ADDENDUM #1
TO
SPECIFICATION AND CONTRACT DOCUMENTS

FOR: ITB-008-2020
Jet A 15,000 Gallon Bottom Load Fuel Tank System

The purpose of addendum #1 is to answer questions received to date and provide 4-page Attachment of project drawings and photographs.

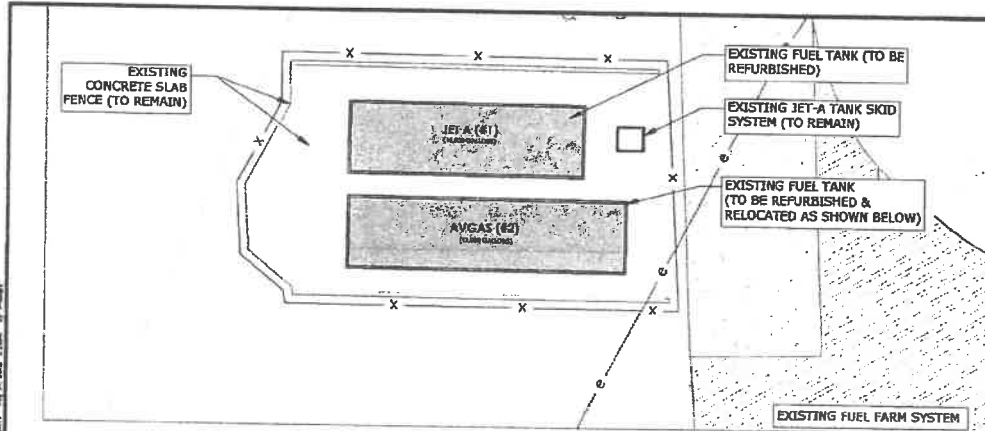
Answer: Yes.
- 5) Specifications, BOTTOM LOAD SYSTEM COMPONENTS, Item c. Where is the East Side? With the equipment platform and canopy on the end of the tank, when facing the equipment platform which side would be the **EAST side**, right or left?

Answer: See attached sketch.
- 6) Specifications, BOTTOM LOAD SYSTEM COMPONENTS, Item i. indicates requirements for “ Four Inch Camlock tank inlet adapter with locking dust cover. “ Is a DRY BREAK disconnect required here? Dry Break valves are available in 1-1/2”, 2” and 3” but not”. Should this be resized to a 3” to match the sizes of the other piping, valves and fittings in the specification?

PROJECT SKETCH
 FUEL FARM IMPROVEMENTS
 Lake City Gateway Airport (LCQ)
 County: Columbia, State: Florida
 Project No.: 20070044.0018
 Date: AUGUST 2018

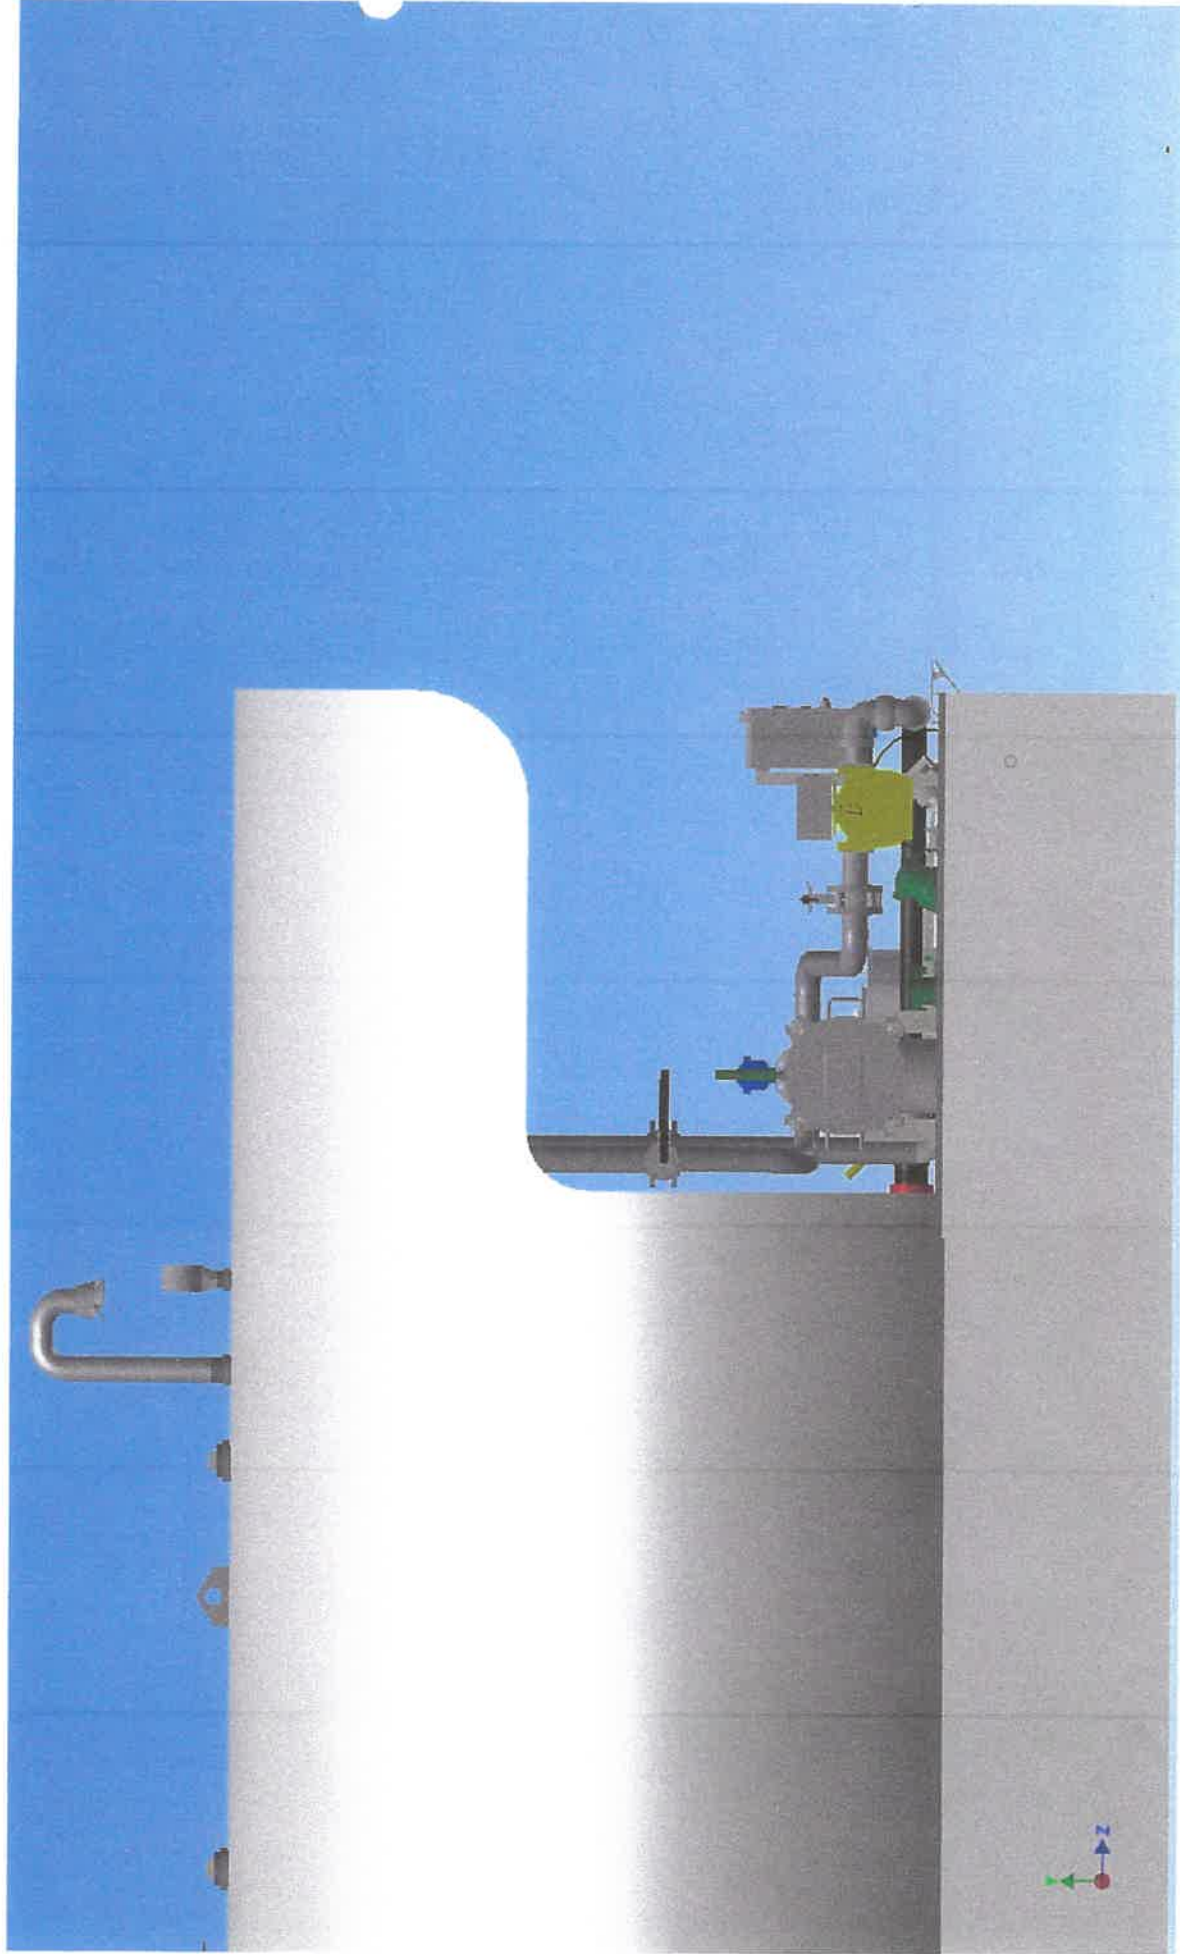
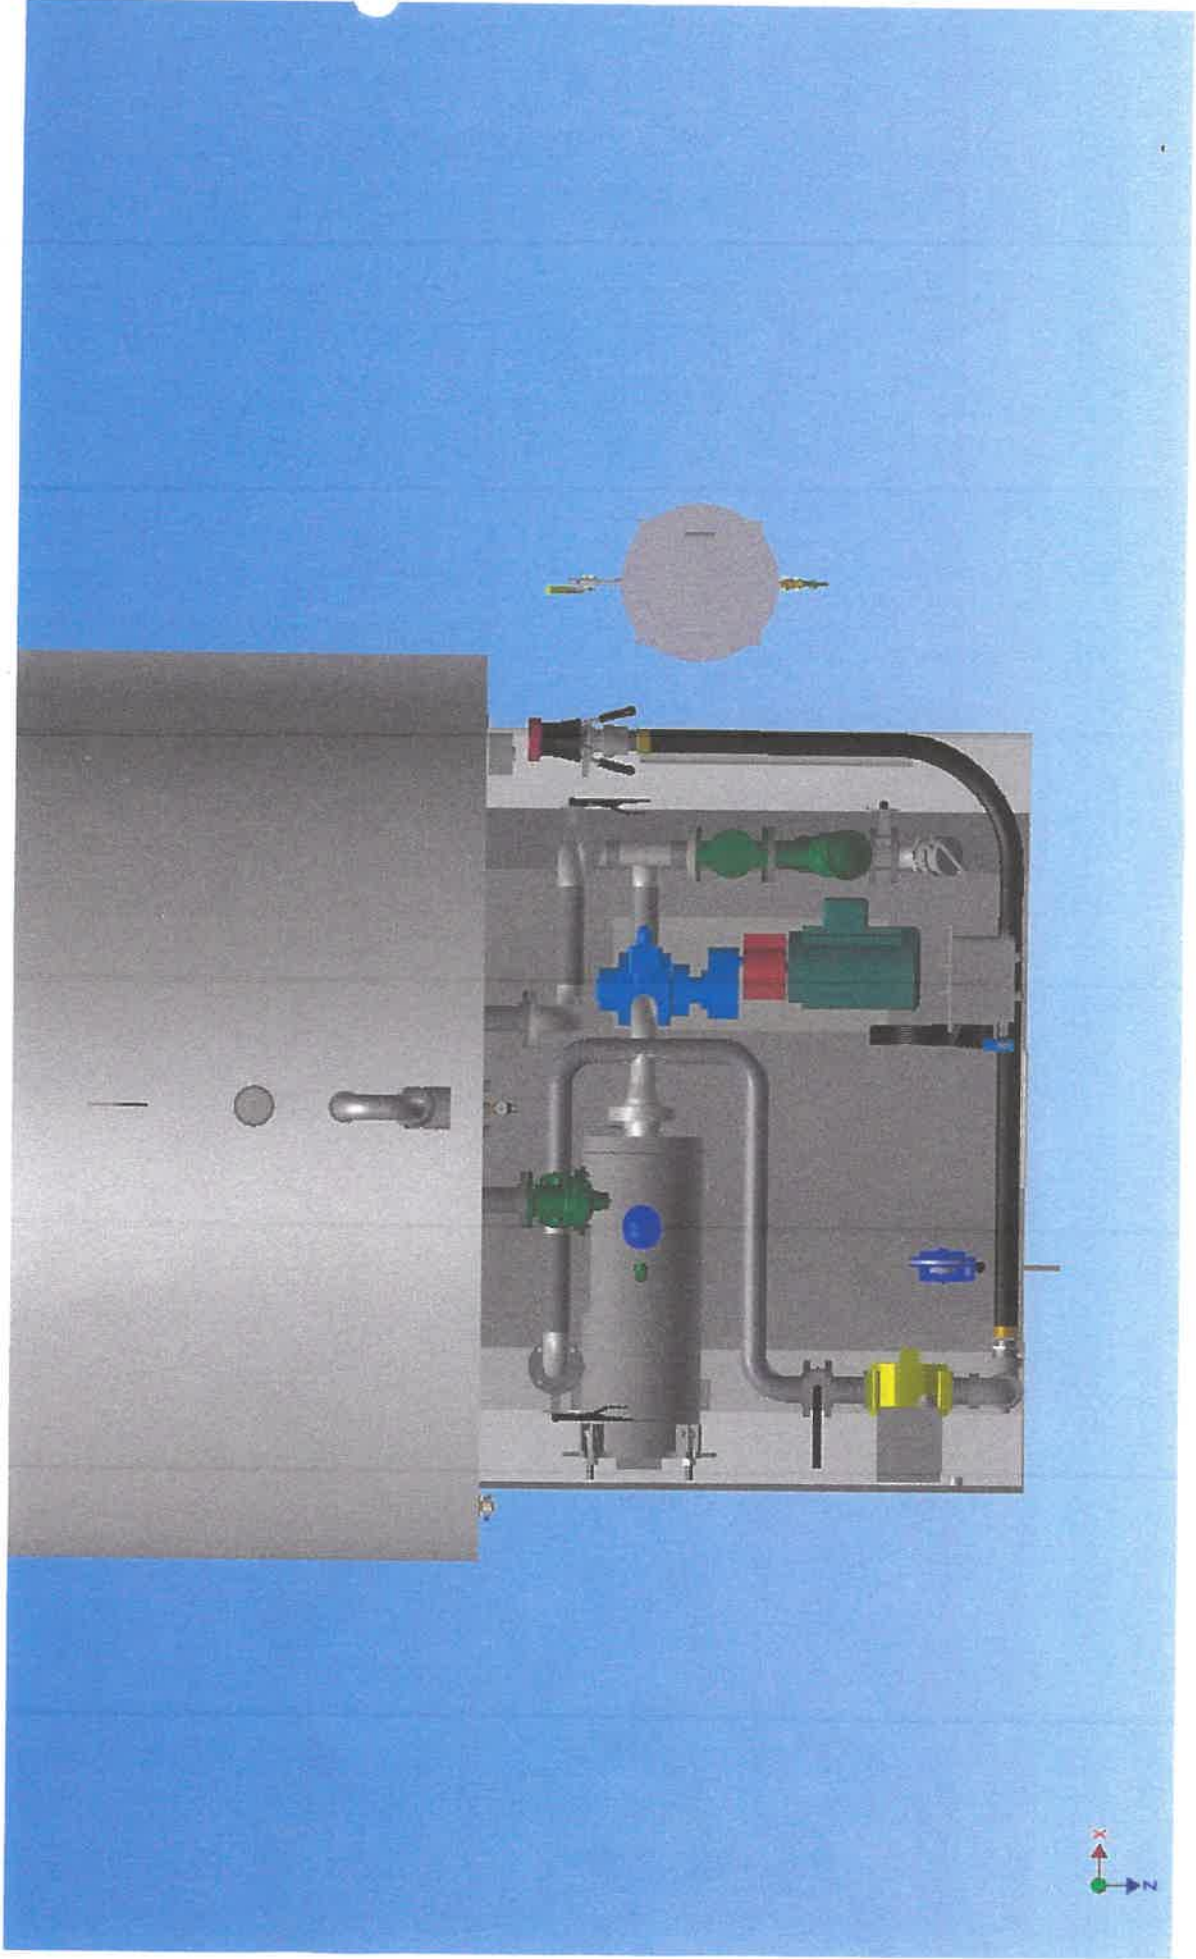
- 1) Are Project drawings available for the site and tank system? If so, where can we get a copy?
Answer: Yes, provided at the Mandatory Pre-Bid Meeting and attached.
